SRPP No	PPSSTH-178
DA Number	DA-2022/938
LGA	Wollongong City Council
Proposed Development	Demolition of existing structures and construction of a 20 storey mixed use building consisting of commercial and retail space with 93 residential apartments and parking for 384 cars.
Street Address	4-8 Parkinson Street and 377-383 Crown Street, Wollongong
Applicant/Owner	Blaq Projects Pty Ltd
Lodgement date	29/08/2022
Recommendation	Deferred
Number of Submissions	First notification: 3 submissions Second notification (amended plans): 1 submission
Regional Development Criteria (State Environmental Planning Policy (Planning Systems) 2021 – Schedule 6 Regionally significant development)	Schedule 6 Clause 2 General development over \$30 million Under Schedule 6, general development over with a capital investment value (CIV) of more than \$30 million is identified as regionally significant development.
List of All Relevant s 4.15(1)(a) Matters	<p>s4.15 (1)(a)(i) Any environmental planning instruments:</p> <p><u>State Environmental Planning Policies (SEPPs):</u></p> <ul style="list-style-type: none"> • State Environmental Planning Policy Planning Systems 2021 • State Environmental Planning Policy No

Figure 6: Building separation precinct areas

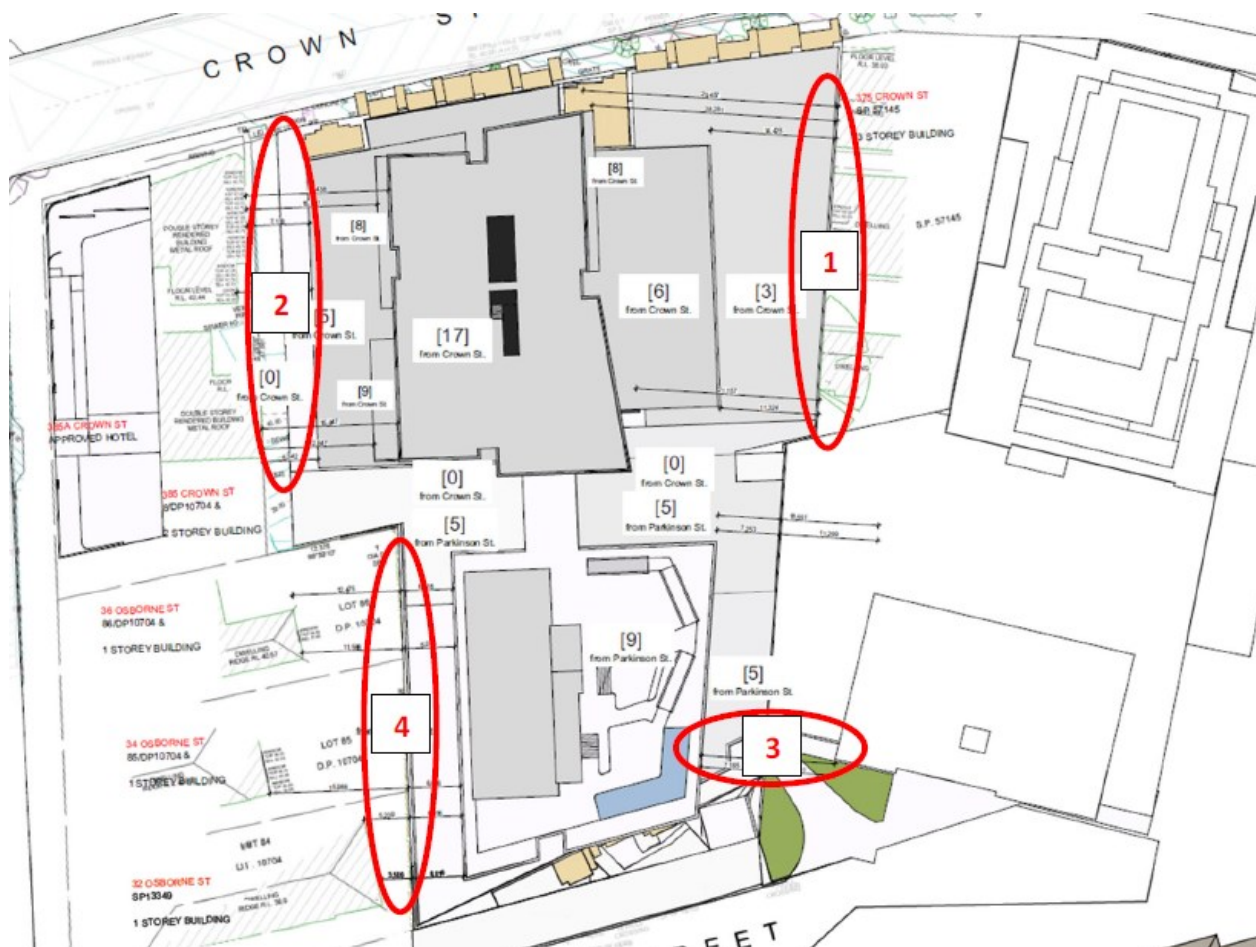
Comment: An exception to the building separation requirements under Clause 4.6 is sought. This has been discussed in Clause 4.6 above. The applicant has provided an overview of the development departure as highlighted by the four precinct areas for the development as listed below:
